Rec'd 7:15 PM
11/21/00

SUBJECT: DRAFT FINAL TECHNICAL STUDY ON SPENT FUEL POOL ACCIDENT
RISKS AT DECOMMISSIONING NUCLEAR POWER PLANTS

DRAFT FOR COMMENT
**Draft Final Technical Study of Spent Fuel Pool Accident Risk
at Decommissioning Nuclear Power Plants**

Figure 3.1 Assumed Spent Fuel Pool Cooling System

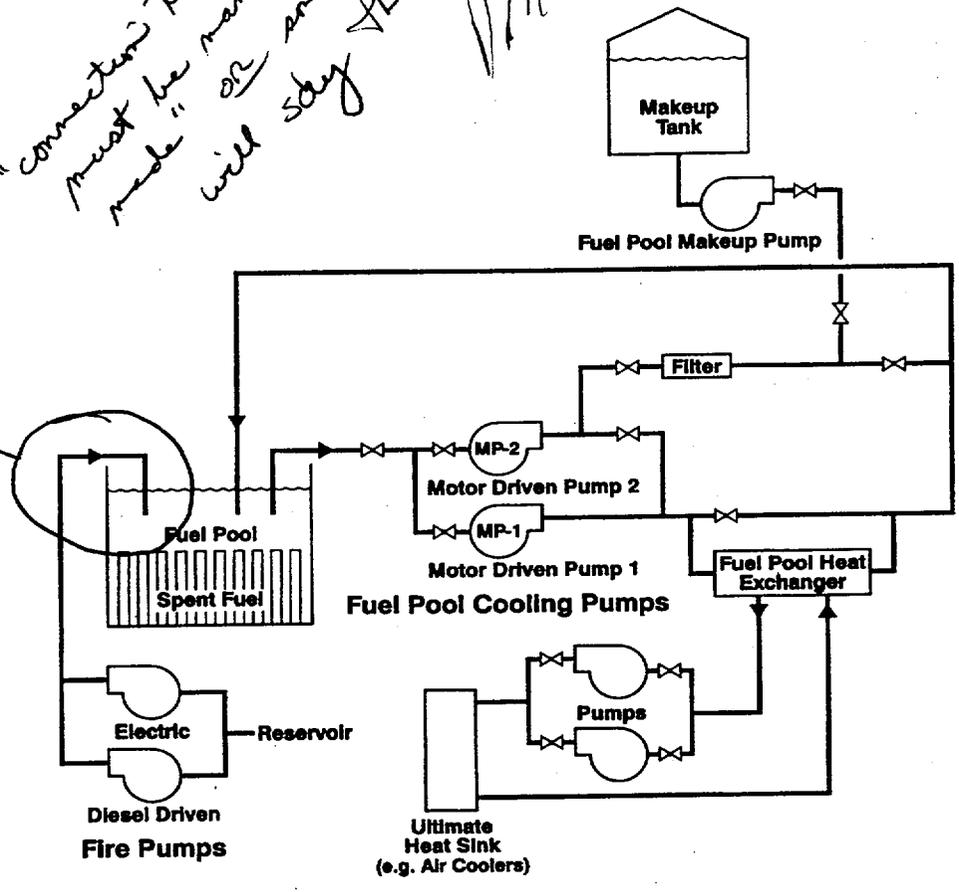
Not sure if this is correct

We should state that staff recognizes the plants may have significantly more capability (eg emergency generators also M4 and CY) but for purposes of establishing a baseline for generic releasing, they were not considered

Indicate "connections to pool must be manually made" or one people will say this is misleading
DAN
